On Monday, July 1, 2013, at 5:00 p.m., in Conference Room A, 281 North College Avenue, Fort Collins, Colorado, a City of Fort Collins Hearing Officer will conduct a public hearing to consider a development project in your area. **The project is referred to as the 429 South Whitcomb Street Carriage House, Project Development Plan, #PDP130006.**

STAFF REPORT

PROJECT: 429 South Whitcomb Carriage House Project
Development Plan, PDP #130006.

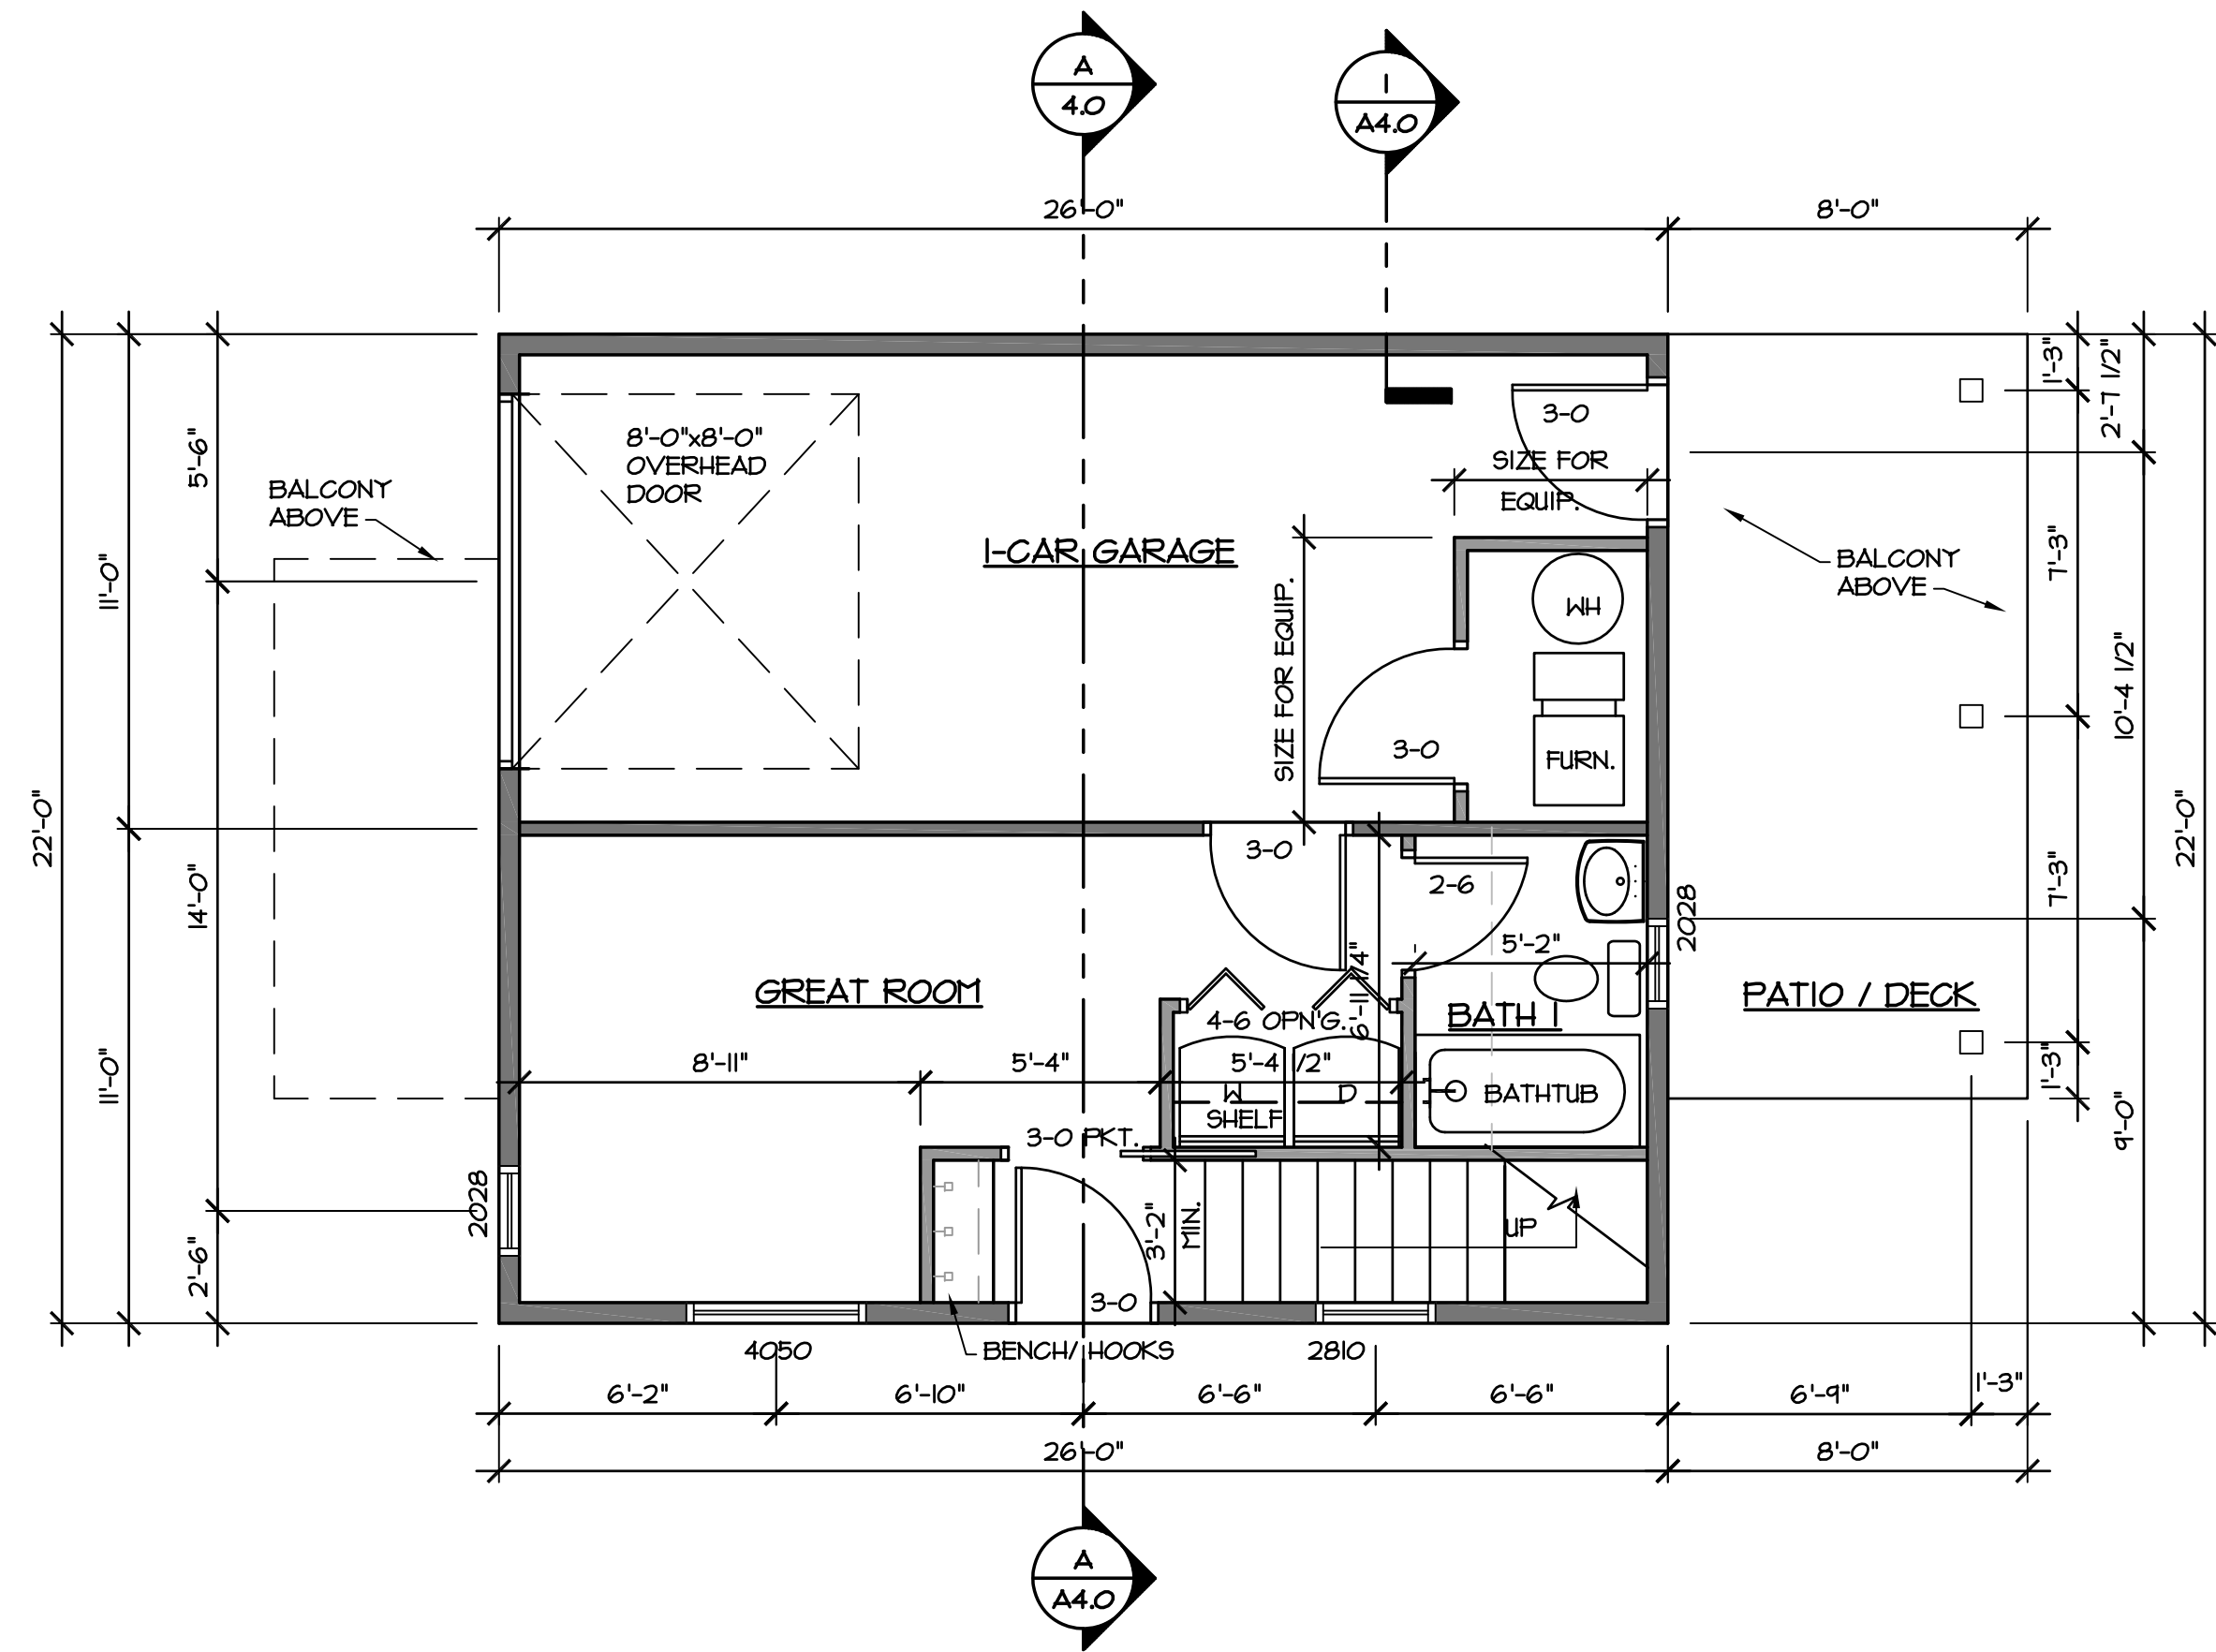
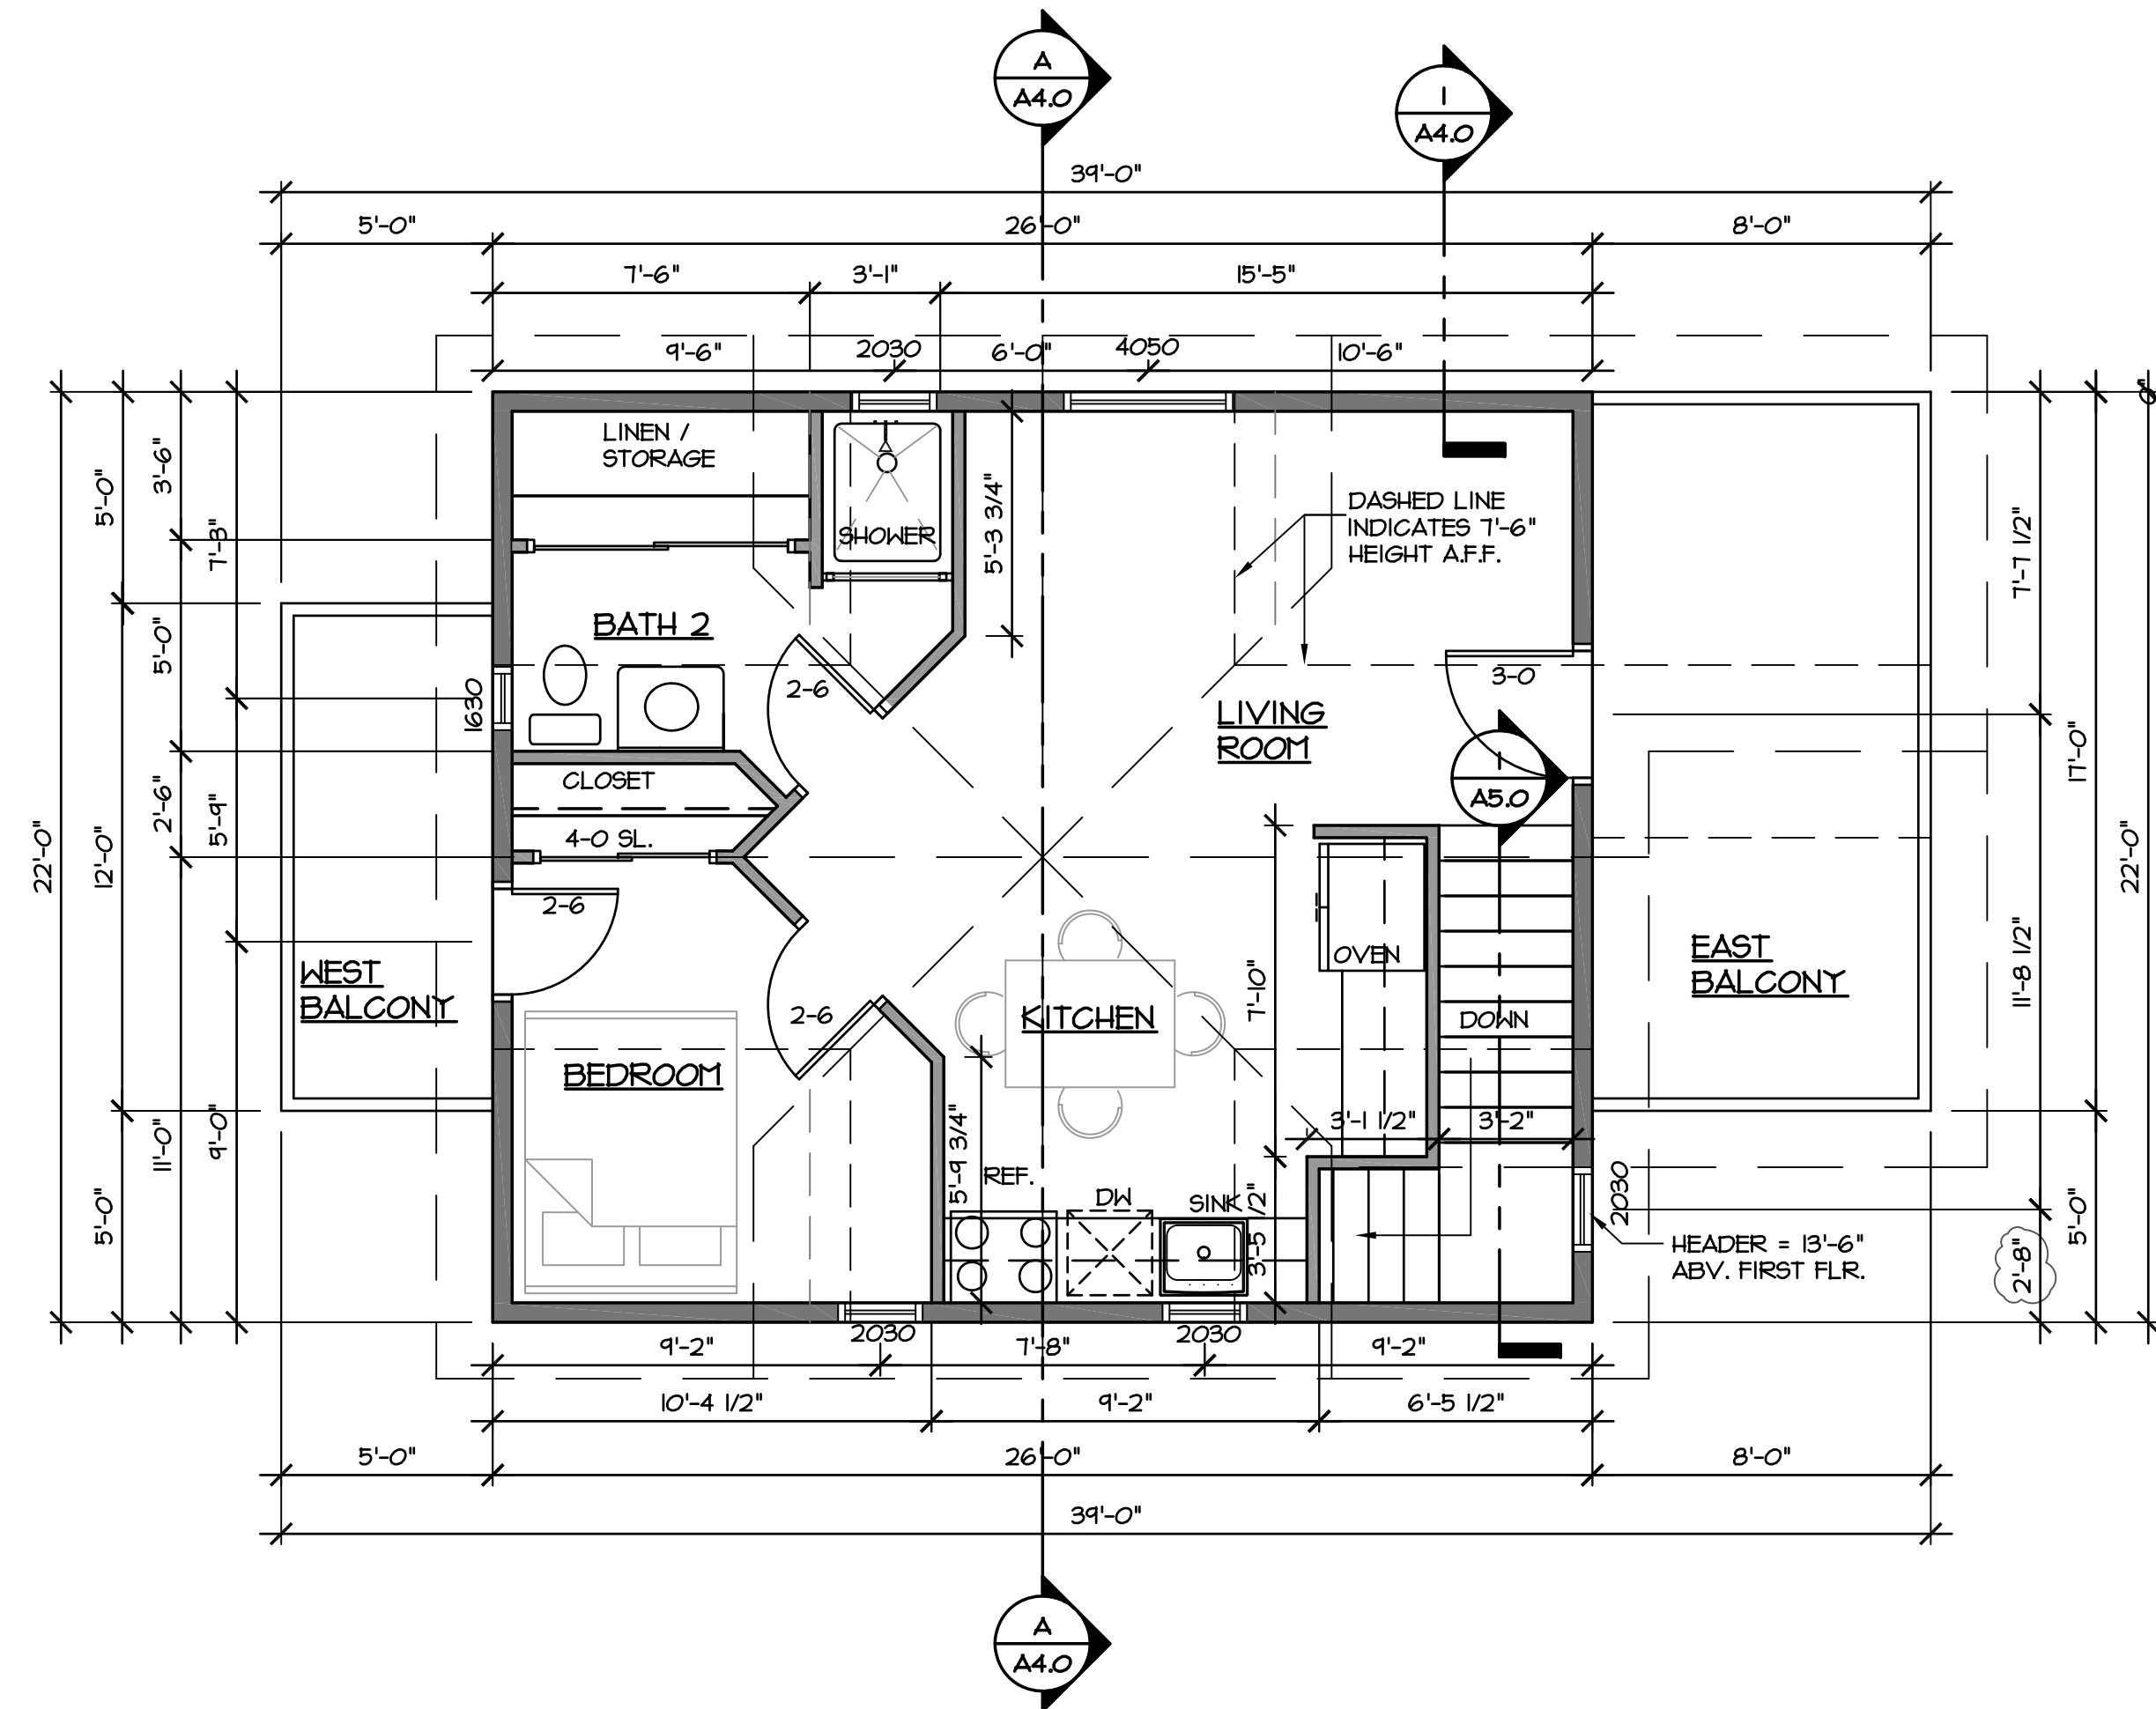
This section requires that any new single-family dwelling proposed to be located behind a street-fronting principal building contain a maximum of one thousand (1,000) square feet of floor area, and the proposed carriage house is in conformance with this standard with 958 square feet total. The calculation of this floor area includes all floor space within the first floor plus the floor area of the second story having a ceiling height of at least seven and one-half (7½) feet. A new single-family dwelling may be located in any area of the rear portion of the existing lot, provided that it complies with the setback requirements of the District, and there is at least a ten-foot separation between dwellings.

The proposed carriage house is positioned on the lot in compliance with the dimensional standards of this section described above. Lastly, this section also requires that the building footprint for such single-family dwelling shall not exceed 600 square feet. The proposed footprint is 572 square feet, in compliance with this standard.
